**Florida
Power**
CORPORATION

June 23, 1994

Re: Request to Amend DeBary Construction Permit AC 64-191015 PSD-FL-167
Request to Amend Intercession City Construction Permit AC 49-203114 PSD-FL-180

GE Frame 7EA Combustion Turbines

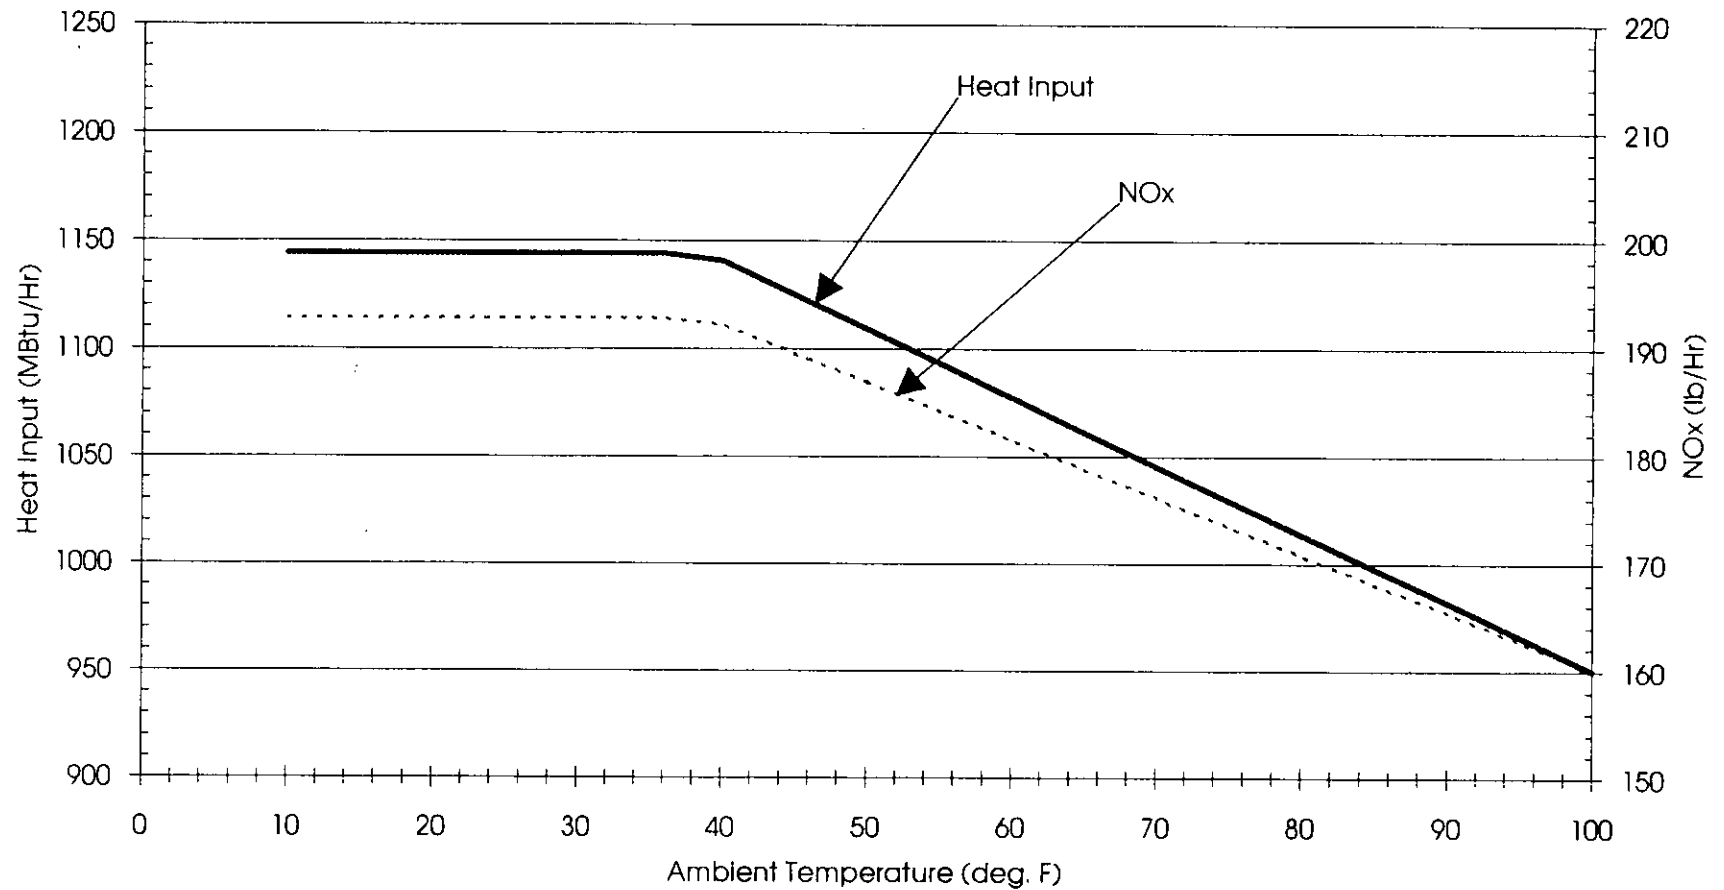
FPC submits the attached heat input vs. ambient temperature curve for application to both the DeBary and Intercession City new combustion turbines. For DeBary, FPC requests that the curve be incorporated into the construction permit. FPC will then request that the Central District amend the operating permit accordingly.

For the new GE Frame 7EA combustion turbines at Intercession City, FPC requests that the DEP remove the current specific ambient temperature and heat input references contained in Specific Condition 4.D. The attached curve would then be incorporated into the construction permit, replacing the specific references.

In the event that a combustion turbine does not achieve 95% of the design heat input capacity as adjusted for average ambient temperature during a compliance test, the entire heat input vs. ambient temperature curve will be adjusted downward by the increment equal to the difference between the design heat input value and 105% of the value reached during the test. The curve will be automatically adjusted upward upon demonstration of compliance at a higher heat input during a subsequent compliance test.
